McDonnell Douglas
Helicopter Company
SERVICE INFORMATION NOTICE

HN-55

SUBJECT VALVE HOUSING MODIFICATION - HEAT CONTROL
VALVE ASSEMBLY, CABIN HEATING SYSTEM KIT
INSTALLATION

Figure 1. Modification of Valve Housing Assembly - Cabin Heat System Kit

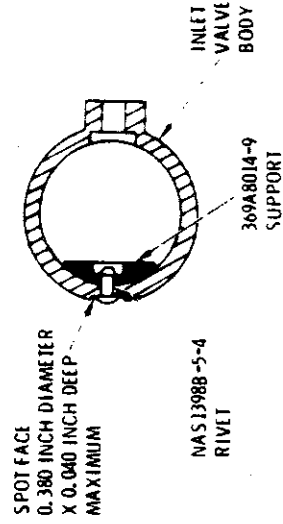
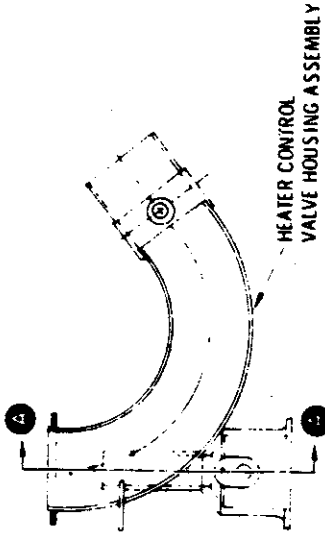
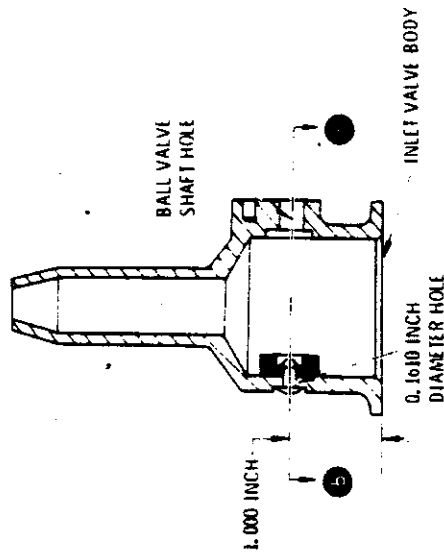
PREFACE: The information given in this Service Information Notice lists a procedure for modifying the valve housing assembly incorporated in the 369H90020 Series Cabin Heating System Kits currently installed on the above affected helicopters. The modification consists of riveting a support block to the inside bore of the inlet valve body, to help seat the ball valve and prevent the ball valve from shifting in service.

- c. Using #20 drill bit, drill rivet hole in the inlet valve body in line with existing hole for ball valve shaft, as shown in Figure 1.
- d. Using spotface tool, spotface outer diameter of inlet valve body as shown.
- e. Coat reworked area with Alodine or equivalent.
- f. Install 369A8014-9 support to inner bore of inlet valve body with NAS1398B5-4 rivet.
- g. Reassemble, reinstall and adjust rigging of heat control valve assembly, per HMI Appendix A.
- h. Perform operational check of heat valve and controls, per HMI Appendix A.
- i. Record modification of heat control valve housing assembly per this Notice in Component Record of helicopter Log Book.
